Powerglide Linkage Adjustment

Powerglide Thrust Washer

Powerglide Thrust Washers Change

Fig. 8

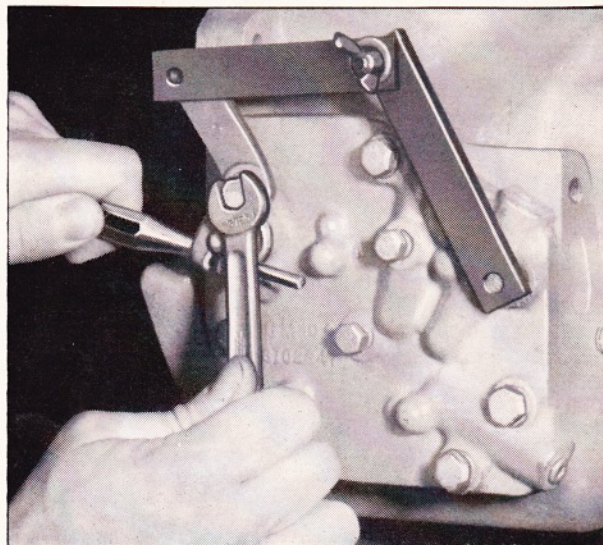
A change has been made in the angle of the transmission throttle valve control outer lever and in the length of the control rod to lower the part throttle upshift range to 12-18 MPH on 1955

Powerglide six cylinder passenger car models. This will necessitate revising the present linkage adjustment procedure at the low and drive valve body where the new outer lever and control rod are used.

The new Throttle Valve Control Outer Lever, Part No. 3720323, and the shorter Throttle Valve Control Rod, Part No. 3715711, will replace the first type lever and rod, Part Nos. 3710634 and 3710632 respectively.

The procedure for adjusting the throttle valve linkage with the new outer lever and control rod will remain the same as described in the 1955 Passenger Car Shop Manual for first type lever and rod with the exception of the outer lever adjustment at the low and drive valve body. The new adjustment should be performed as follows:

1. With the control rod disconnected from the lever, remove the top bolt and lockwasher on rear edge of low and drive valve body cover.
2. Loosen the outer lever adjusting bolt.
3. Remove the outer lever assembly clamp bolt and install a suitable tool through the clamp bolt slot to assist in rotating the lever.
4. With the throttle valve outer lever positioning gauge J-5906 set at 6", rotate the outer lever counterclockwise to permit the gauge to be installed in top bolt hole and lever. Install gauge as shown in Figure 8.
5. With the clamp and outer lever rotated counterclockwise to the open throttle position (to a definite stop), tighten adjusting screw (fig. 8).

Figure 1

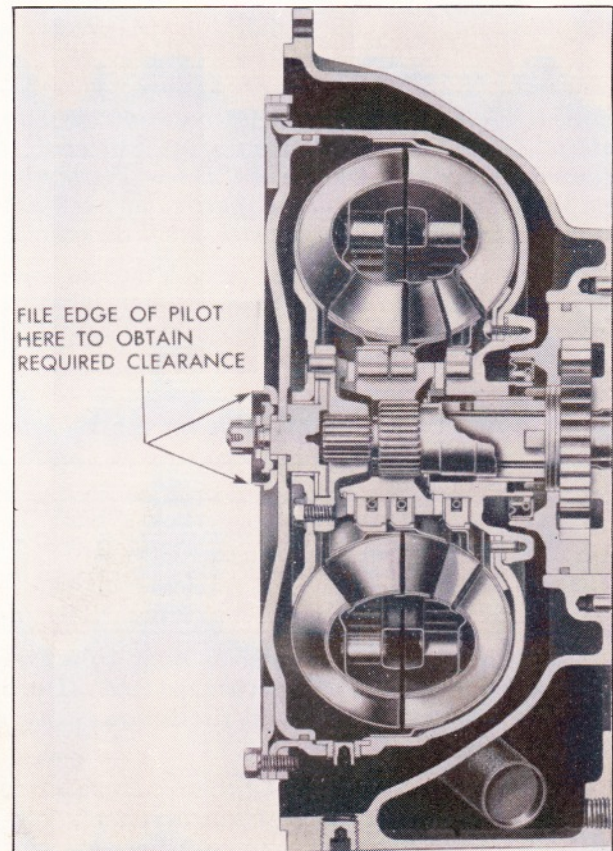
In cases where interference is encountered between the cover pilot and the crankshaft when installing a service crankshaft on 1950-52 Powerglide models, a slight rework will provide the necessary clearance. Clearance may be obtained by filing the edge of the pilot as indicated in Figure 1.

Figure 9

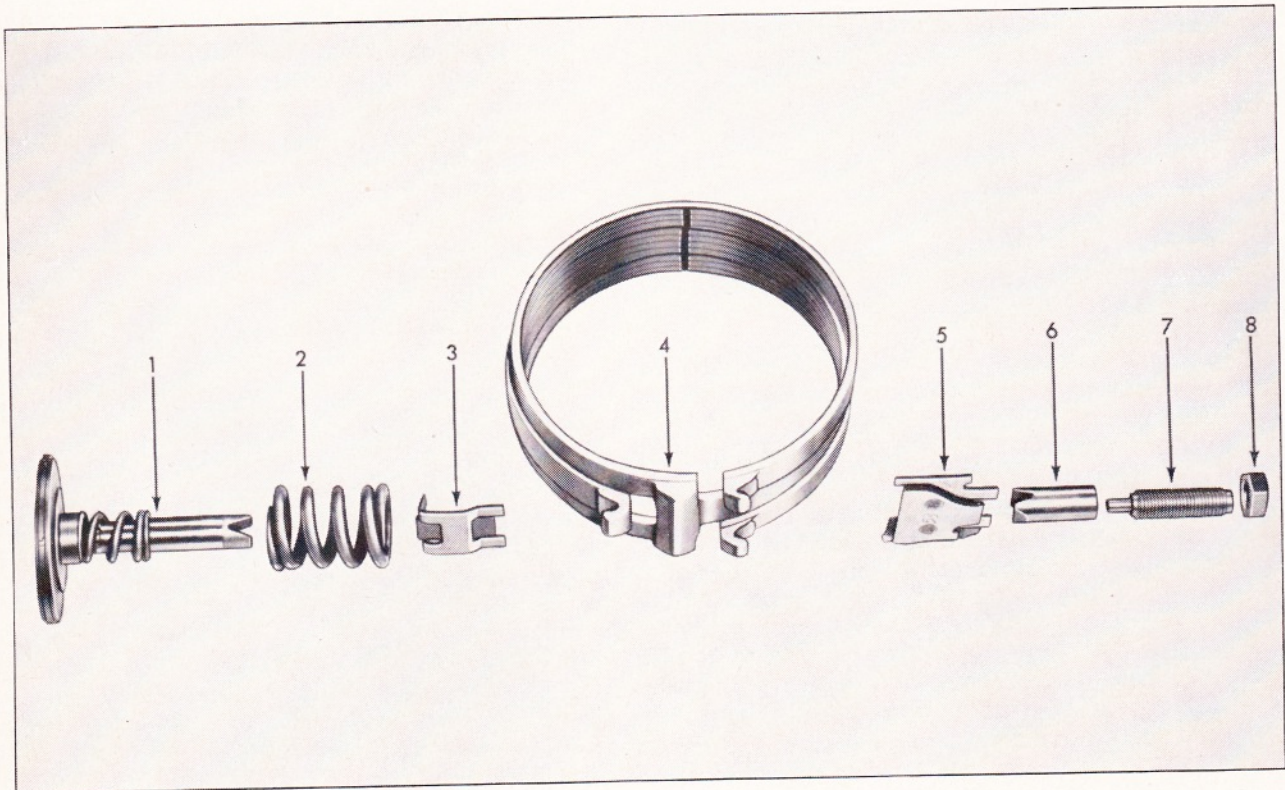
Improper installation of the Powerglide low brake band anchor strut (5, fig. 9) will limit movement of the band.

Service personnel are cautioned that the guide stamping of the anchor strut assembly must be installed *toward* the band as illustrated. This same illustration is carried as figure 86 in Section 7 of both the 1955 and 1957 Passenger Car Shop Manuals.
